H12169

DESCRIPTIVE REPORT

General Locality Kuskokwim River

Sublocality South of Napakiak

Figure 2 – Junction of H12169 (turquoise) with H12168 (purple) and H12170 (orange) from this project (OPR-R341-KR-10) on chart 16304 (2nd edition, January 2005).

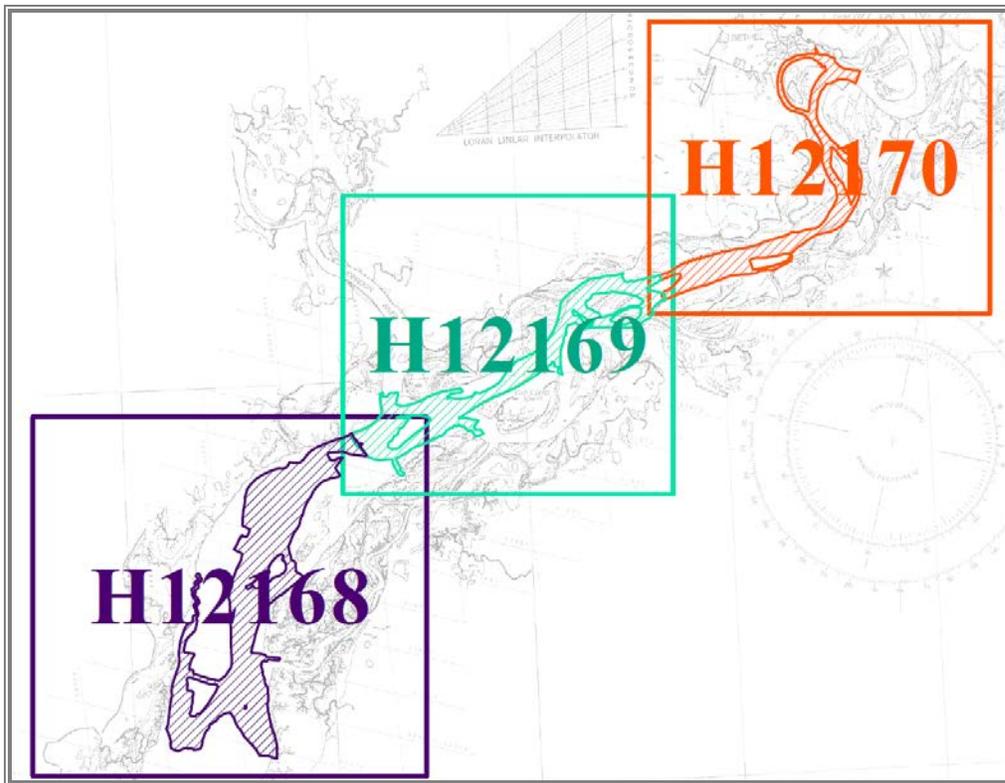
This survey junctions with two other contemporary surveys. The junction is described in the following table and figure 2¹².

¹² A common junction was made with survey H12168 and a junction with H12170 will be made during its compilation.

Figure 10 – Example of shoreline discrepancy on chart 16304. Multibeam BASE surface and tracklines plotted on top of charted MHW.

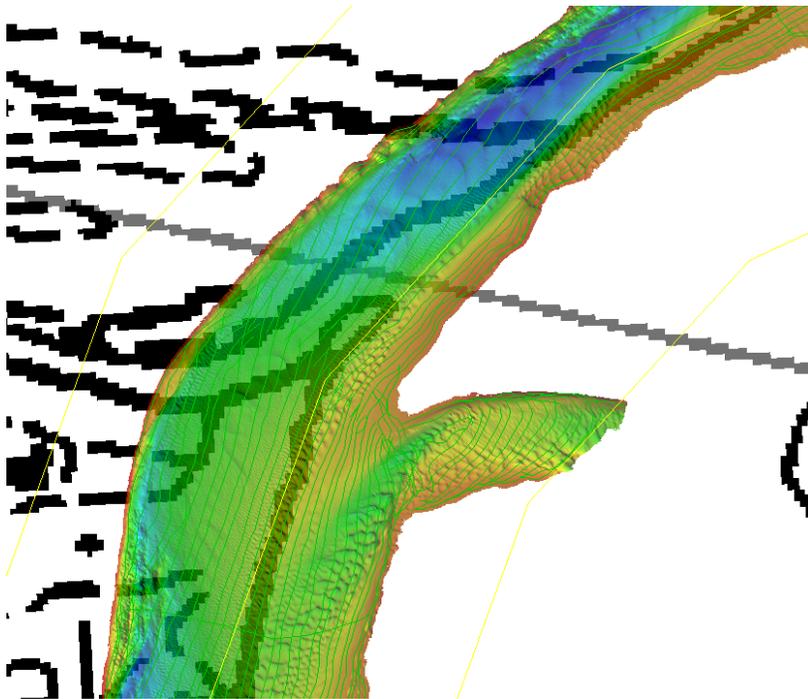
- Survey data shows up to 290 meters of discrepancy with shoreline as portrayed on chart 16304 in the vicinity of 60-41-37 N, 161-57-43 W, due to significant erosion of the river bank. This survey was not tasked with shoreline verification; recommend updating shoreline detail²⁹. See figure below

²⁹ Concur. Update shoreline using latest GC from RSD.
